# **Response to Requests for Additional Information for the Review of the ARCADIA<sup>®</sup> Reactor Analysis System for PWRs Methodology Description and Benchmarking Results Topical Report**

ANP-10297Q1NP  
Revision 1

AREVA NP Inc.

**Figure 15-6-A - EPICURE UH1.2 Reference Fission Rate Distribution**

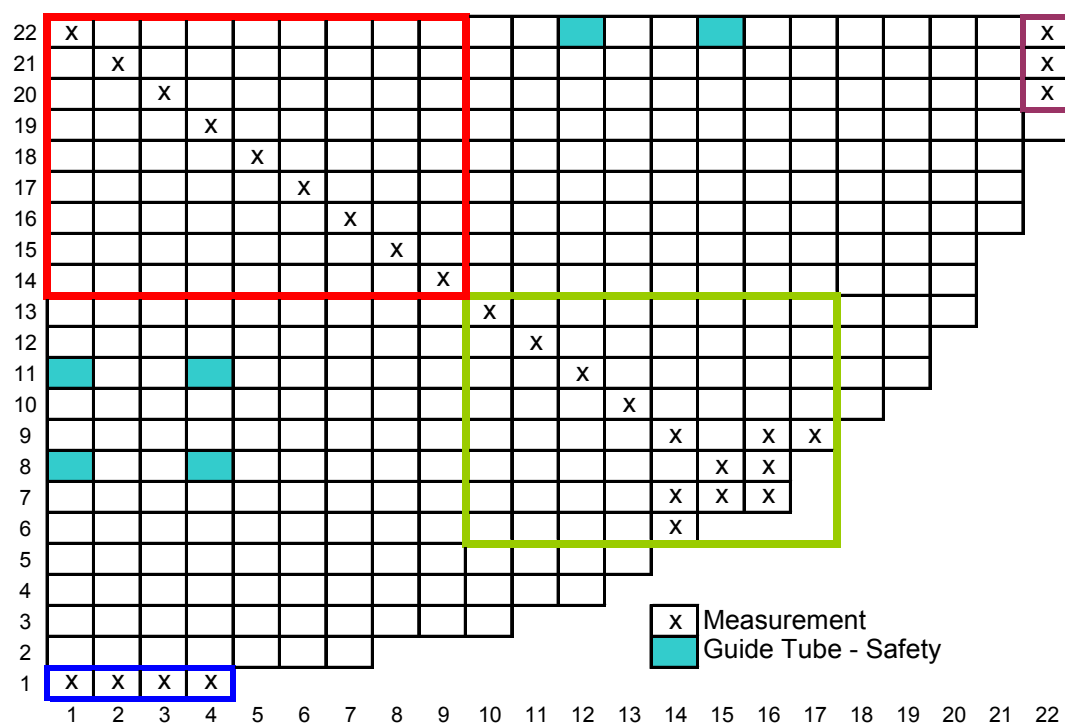
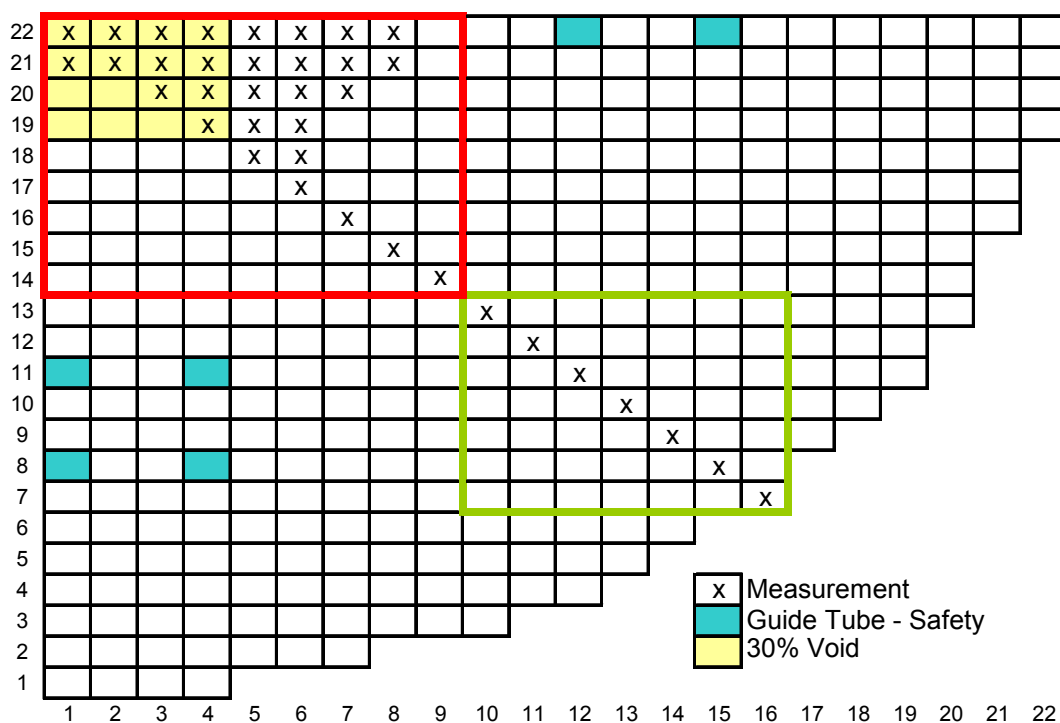
**RAI 15** Please provide fission rate distribution maps similar to Figure 12.2.1-1 for other criticals as well. Also please the predicted and measured peak pin fission rate locations, the peak pin fission rate differences and maximum, minimum fission rate differences in the fission rate distribution comparison in Tables 6.2-6 through 6.2-10 [Page 6-7].

Fission rate distribution maps similar to Figure 12.2.1-1 are presented for each critical configuration in Figure 15-1 through Figure 15-16. Due to their size, maps for the EPICURE and KRITZ configurations are split into smaller maps. In these cases a description of the complete map is presented first with the definition of the zones that are used for the smaller maps. The Babcock & Wilcox experiment fission rate distributions are updated as part of the response to RAI-36.

Figure 7.3-2: Heavy Reflector Geometry

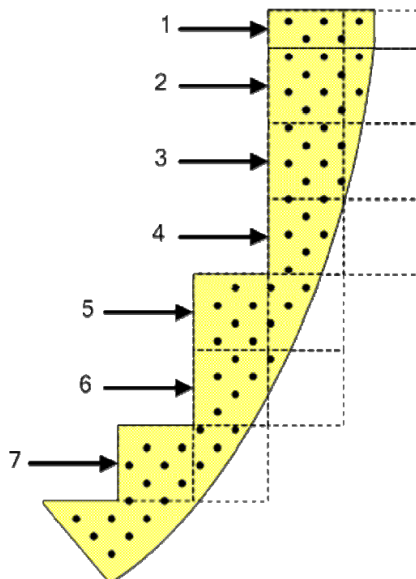
**RAI 22** For “heavy reflectors”, (reflectors comprised of a thick steel shroud and low moderation inside the core barrel), the water scattering cross sections are calibrated with factors “deduced from the comparison of the 2D power density distribution calculated by ARTEMIS with the corresponding reference MCNP result”. The methodology used to “deduce” these factors should be documented and some justification should be made as to the application of the modified scattering cross section to other plant/fuel types. A quantification of the magnitude of the calibration should also be provided. [Page 7-4]

Two types of adaptation factors were found to be sufficient for avoiding heavy reflector induced in/out or azimuthal trends, one for non in-side (edge) and one for re-entrant (corner) reflector nodes. The classification of the heavy reflector nodes is (see Figure 7.3-2 of the Topical Report):

reflector nodes 1, 2, 3, 4, 6 → edge  
reflector nodes 5, 7 → corner

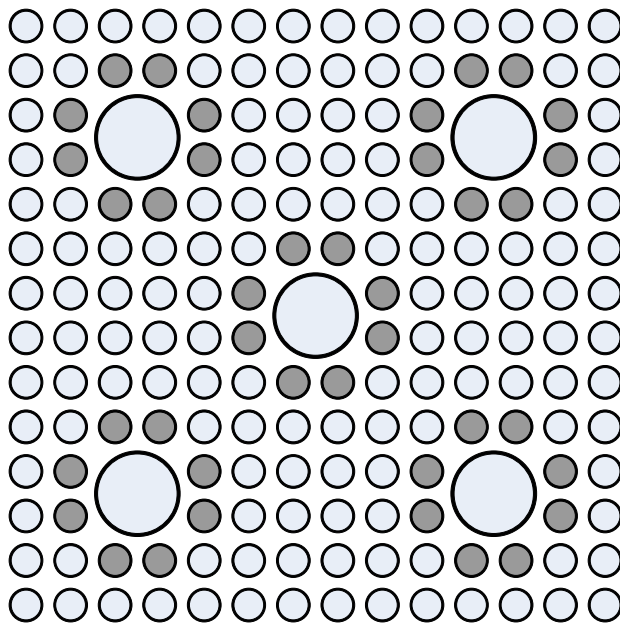
**RAI 24** Figures 7.3-4 and 7.3-5 look like full core but the documentation states that MCNP was run with octant symmetry. Why are full core results provided?  
[Page 7-5]

The represented cores are octant symmetric. Nevertheless, the ARTEMIS Calculations were performed in full core geometry. For direct application of existing scripts the MCNP results were unfolded to full core geometry.

**Figure 28-G1-1: Plant G1 Cycle 26 Critical Boron Concentration vs. Burnup**

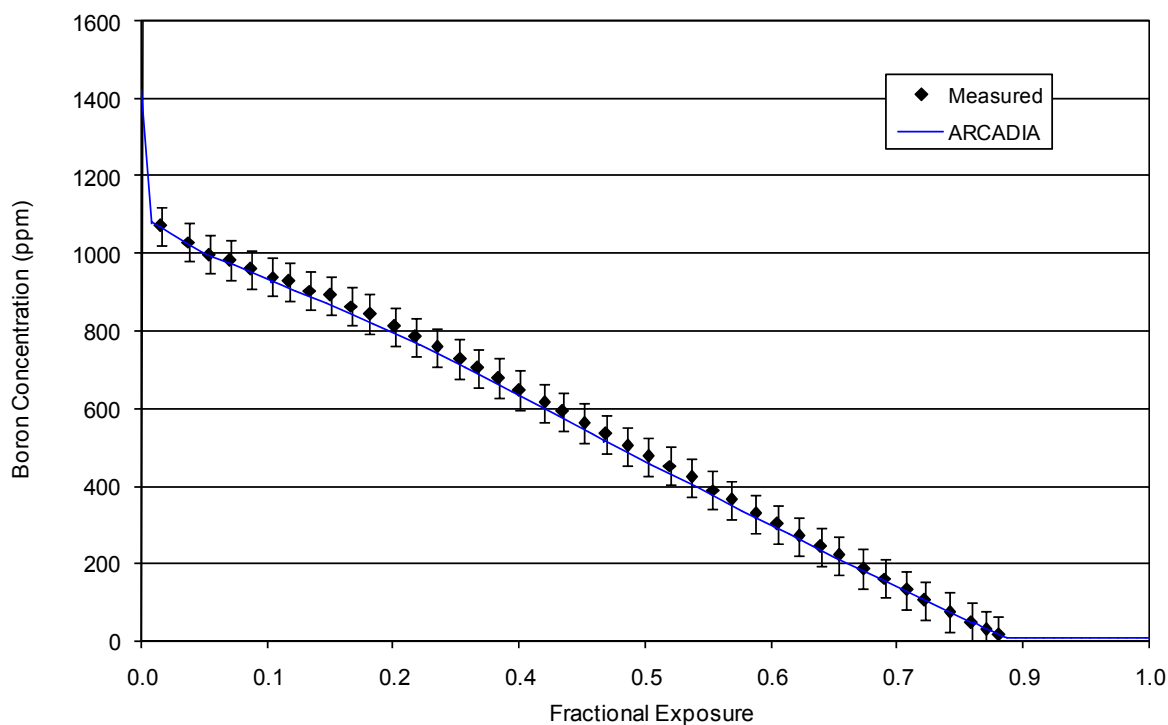
**RAI 28** Plant G1 Cycle's 27 and 28 had a BOC B10 abundance of 19.2%. Also, Cycle's 29 and 30 used enriched B10 at about 30%. The report states that the Cycle 26 HZP boron measurement "may be suspect because of the B10 isotopic abundance was not measured". However, there are no unexpected comparisons at BOC HFP, which indicates that no additional B10 correction should be necessary at HZP. The report does not clearly describe which boron measurements are adjusted for B-10 content, and which are not. B10 corrections, both at HZP and HFP (i.e. B-10 depletion, if included) should be applied consistently for all cycles and should be clearly documented. [Page 10-31,1035]

Erroneously the critical boron adjustment in Table G1 10.3.4-1 and in Figure G1 10.4.4-1 of the Topical Report for Cycle 26 was applied to the calculated values to make them relative to the measured B-10 abundance instead of using the assumed measured B-10 abundance to adjust the measured critical boron concentrations such that they are relative to concentrations with natural boron. The values have been updated and are presented in Table 28-G1-1 and Figure 28-G1-1 (see below).

**Figure 31-A-1: Boron Differences**

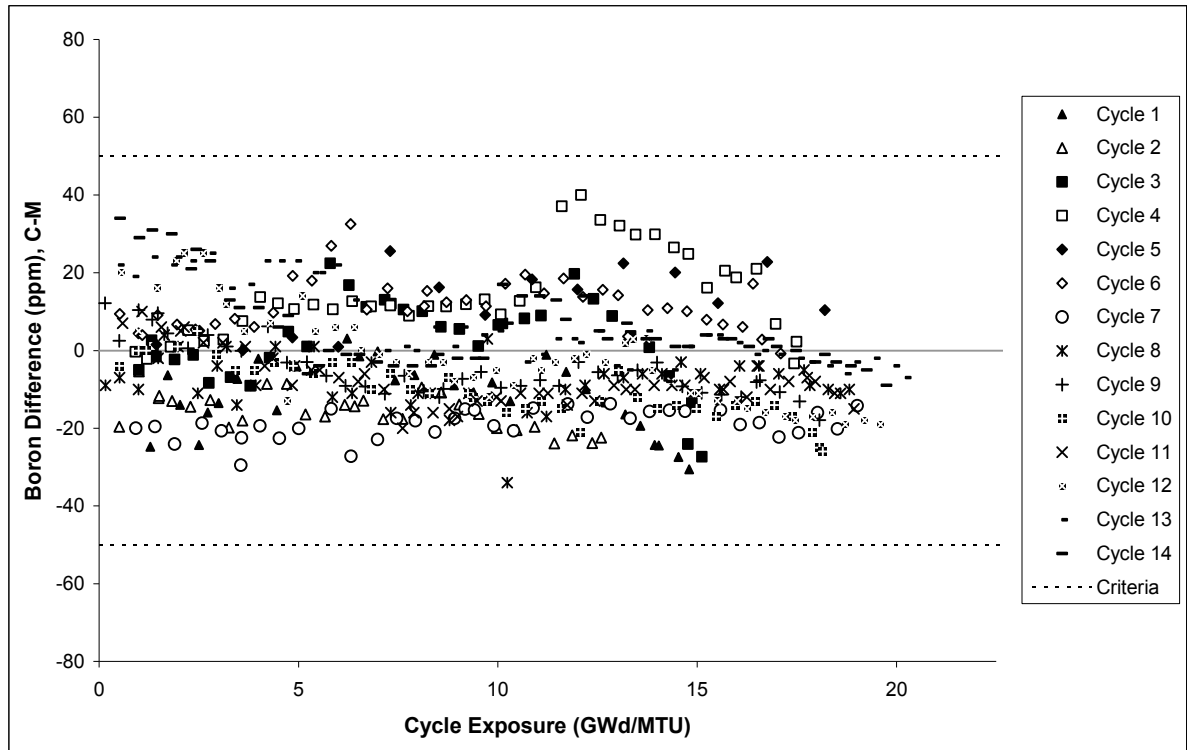
**RAI 31** The boron letdown curves are presented for each cycle individually as a function of fractional cycle length. This scale is confusing because it prevents some comparisons from cycle to cycle, and inhibits the ability to approximate cycle length-based effects, such as gadolinia depletion, B-10 depletion, and design implications for 24 vs 12 month cycles, etc. Furthermore, the letdown curves are presented on an absolute value scale, which makes individual deviations very hard to discern. A summary plot of boron difference for all cycles (to compare against each other, potential by plant), plotted versus a non-relative scale such as cycle exposure would be useful. [Page A-9+]

Summary plots of the boron deviations are provided. These plots use an absolute scale for burnup and present the boron deltas for all cycles by plant.
